Service Bulletin

NO. 320

Studebaker and Packard Clipper

CARBURETOR MODIFICATIONS ON 1957 GOLDEN HAWK 57H-K and 1957 PACKARD 57L MODELS

Fig. 1

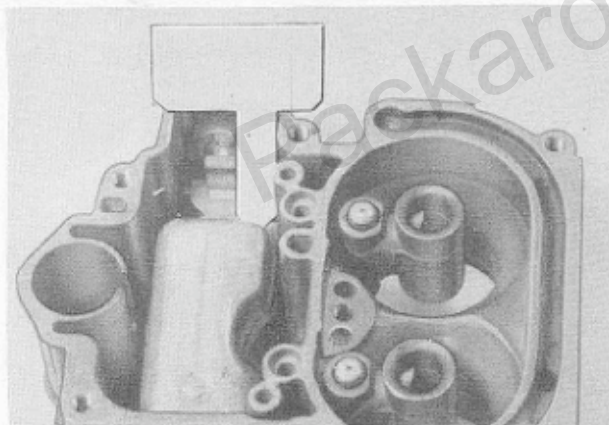
A new Air Horn Gasket, Part No. 1543362 has been designed in which the vent hole in the gasket is not in line with the bowl vent tube, also a Baffle, Part No. 1543363, (see Fig. 1) has been released to be installed in the bowl chamber between the float and float needle valve (see Fig. 2). This baffle restricts the surge of gas from one end of the bowl to the other.

Fig. 3

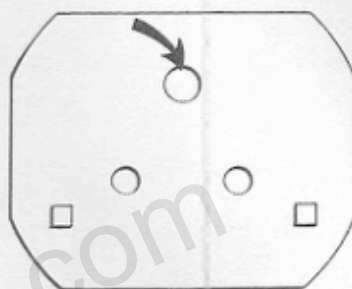
A 1/4" hole will be placed in the choke butterfly to eliminate the over-rich condition after starting the engine when cold.

A lean condition that exists after starting has been corrected by shortening the choke stove-to-carburetor pipe 1 1/4". The above mentioned 1/4" hole should be drilled in the center of the choke butterfly in the wide side (see Fig. 3) and the choke stove-to-carburetor

pipe shortened 1 1/4".
